Team Update 05

01/26/2016

Figure 4-1: BUMPER Corner Examples

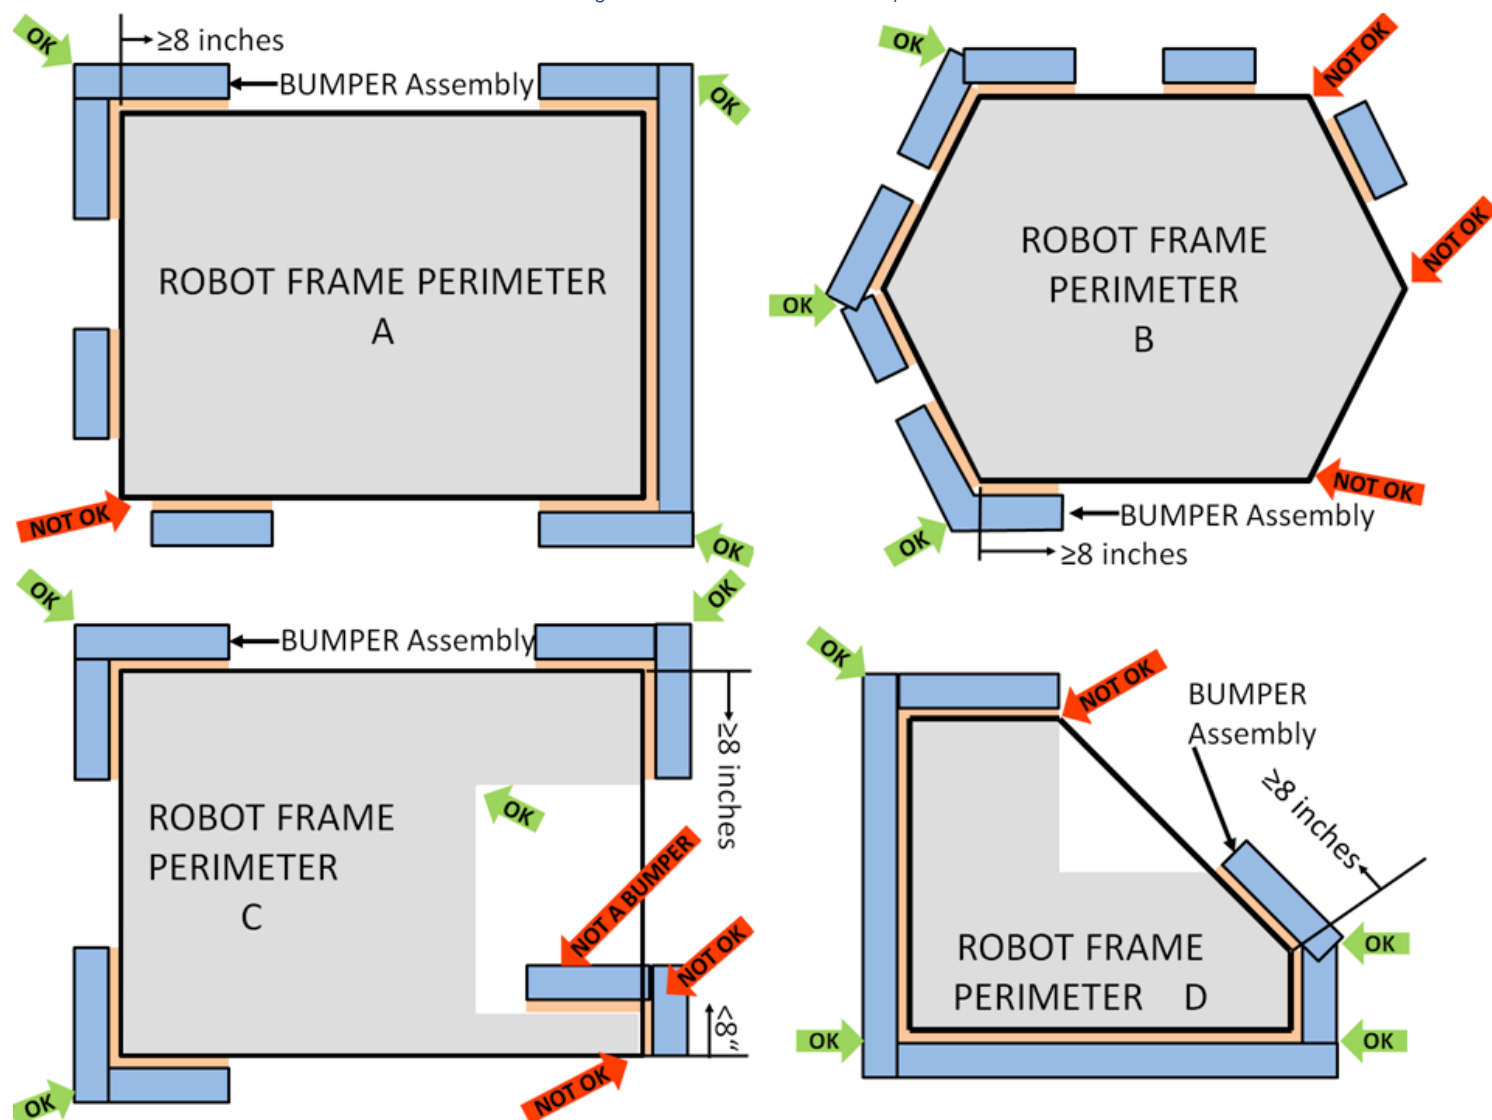
■ Figure 4-3: BUMPER Corner Examples includes an revised lower-left right corner in ROBOT FRAME PERIMETER C.
